VIRGINIA ELECTRIC AND POWER COMPANY
RICHMOND, VIRGINIA 23261

VIRGINIA ELECTRIC AND POWER COMPANY
NORTH ANNA POWER STATION UNITS 1 AND 2
REVISIONS TO STATION EMERGENCY PLAN
REVISIONS TO EMERGENCY PLAN IMPLEMENTING PROCEDURES

NORTH ANNA EMERGENCY PLAN REVISION 17 SUMMARY

FIGURE 7.1

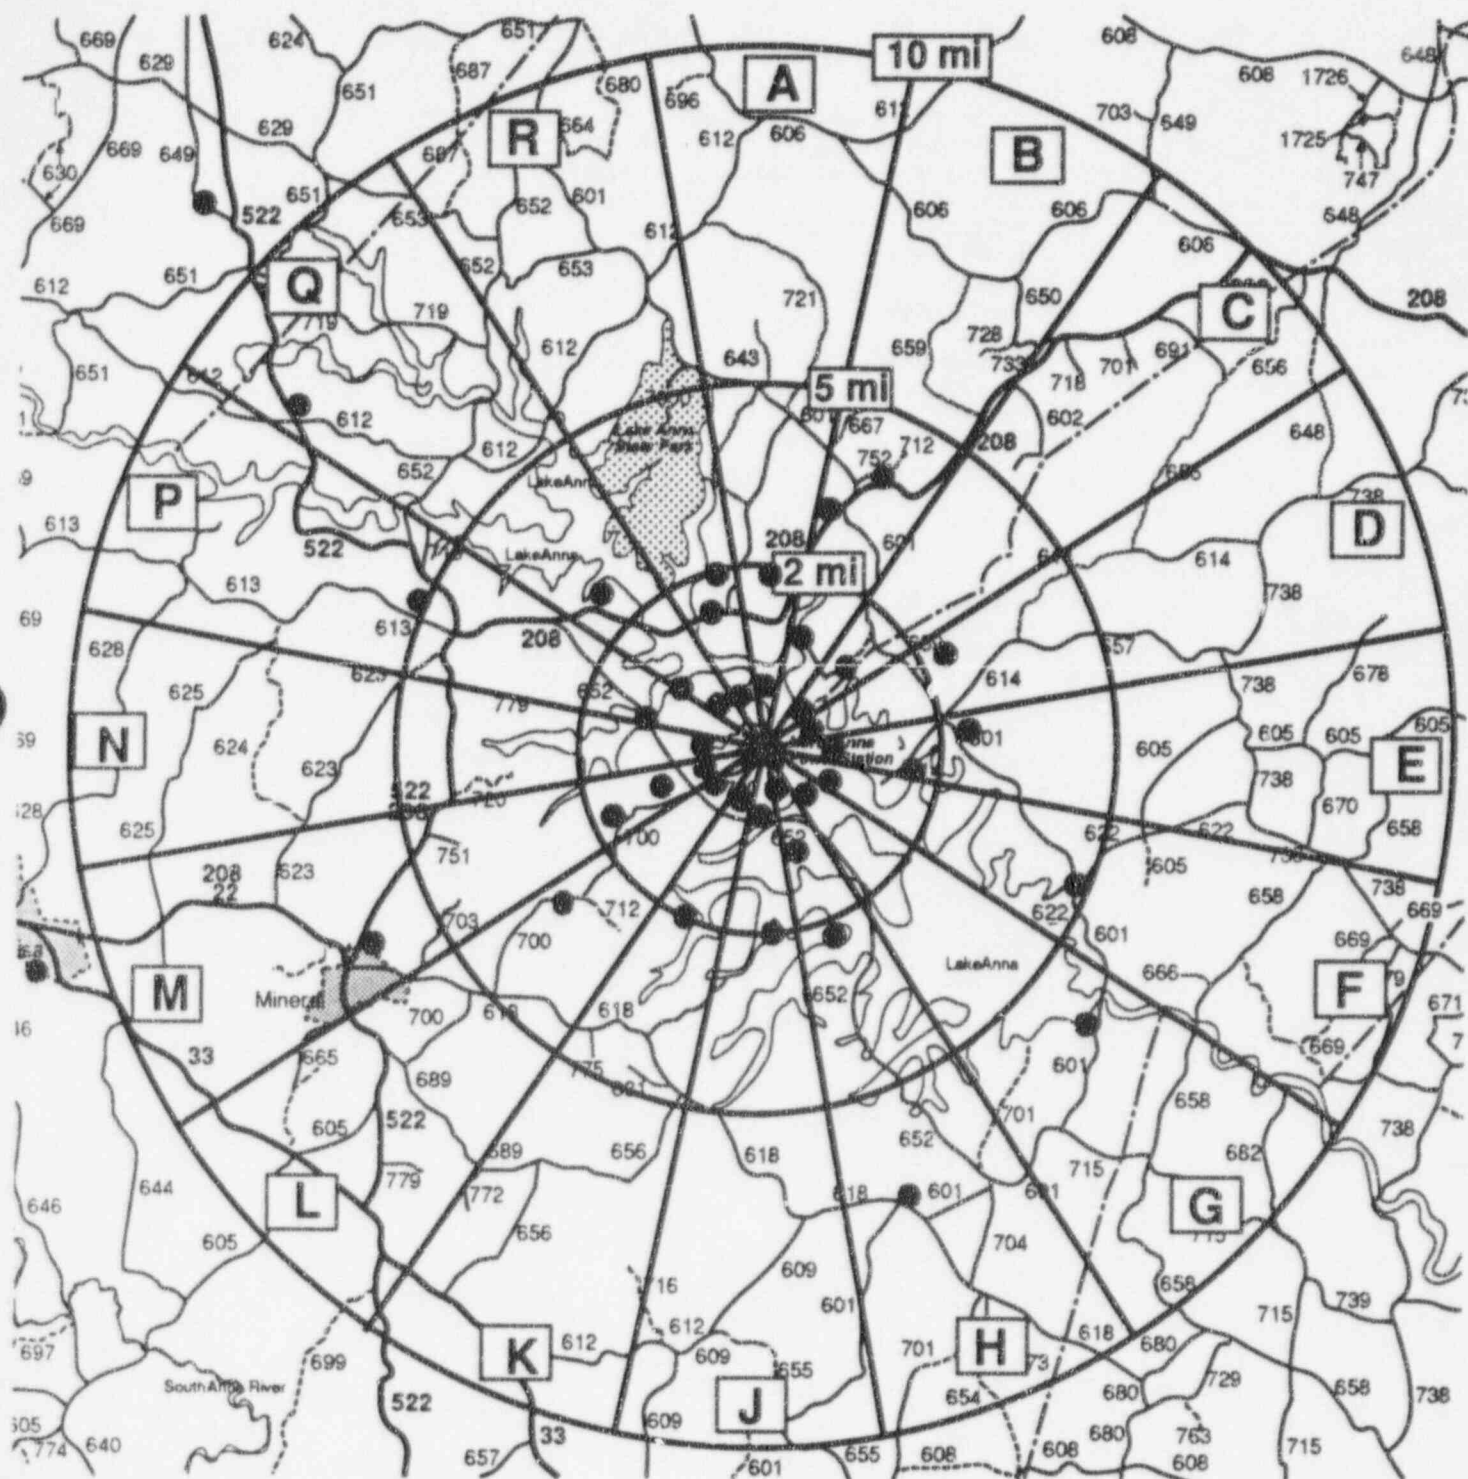
Updated monitor location listing and removed non-emergency plan (i.e. environmental) TLDs in Figures 7.1 and 7.2.
